**ALTERATION TO A HISTORIC PROPERTY STAFF REPORT**

Site: 37 Albion Street C. 1860 F. G. Williams House  
Case: HPC 2014.034 Single Building Local Historic District

Date of Application: May 29, 2014  
Legal Notice: *Replace approximately 7' of wood gutter with aluminum*  
Staff Recommendation: *Deny Certificate of Appropriateness; Recommend Certificate of Non-Applicability*  
Date of Public Hearing: July 15, 2014

*37 Albion Street. 2014 - Details*

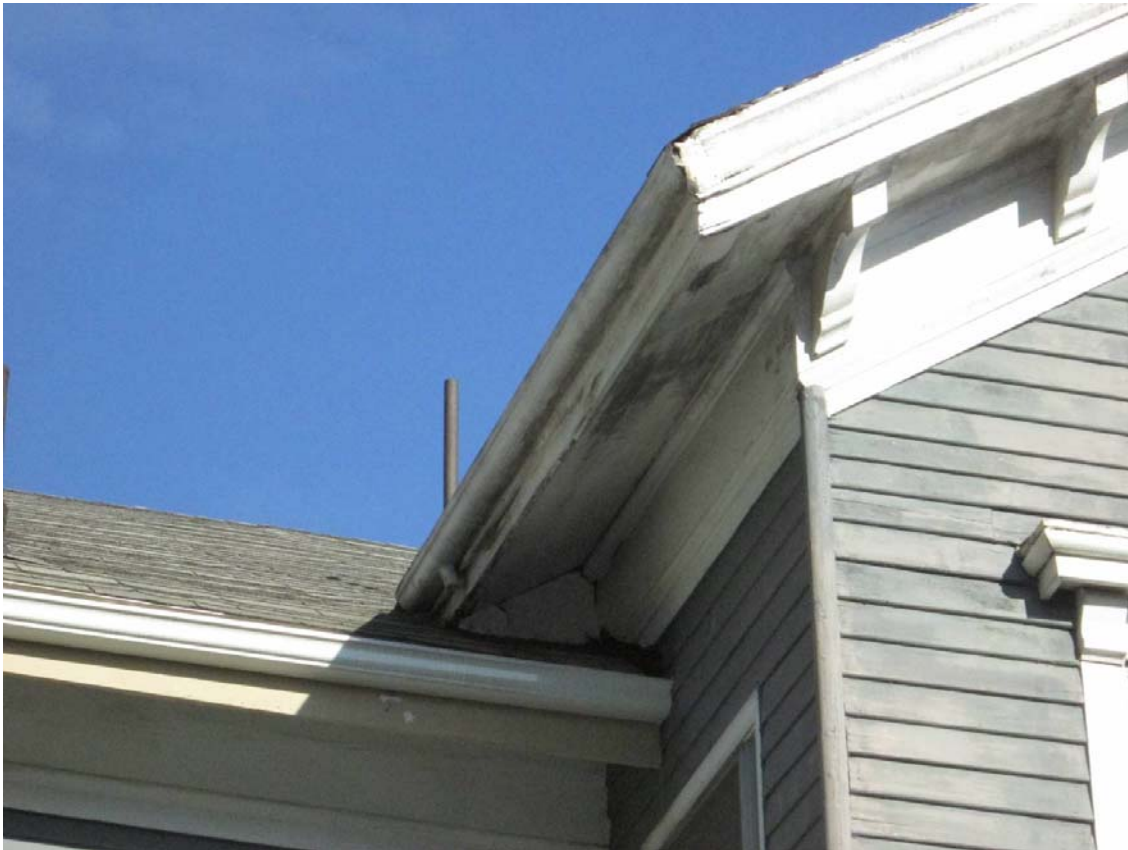
The house is generally well-maintained, although it does need to be painted and the roof needs to be redone. The existing gutter system is with the exception of approximately seven feet on the north-west side of the main block of the house been replaced with aluminum. See photos at the end of the document.

While this is only a small portion of the gutter system, wood gutters are the most appropriate gutter system for a house of this period. The loss of any historic fabric not replaced

The proposed gutter will not be the same as the existing and does not preserve the character of a wood gutter.

1. The roof will be stripped and re-shingled with 3-tab asphalt shingles with no ridge vent.
2. The chimneys shall be re-flashed with in-kind materials as needed.
3. The rotted and damaged fascia shall be replaced with wood fascia.
4. The aluminum gutters may be replaced with aluminum gutters.
5. The remaining wood gutter shall be replaced with a new wood gutter with the same size and profile as the existing wood gutter.
6. The down spouts shall have the same size and shape as the existing.
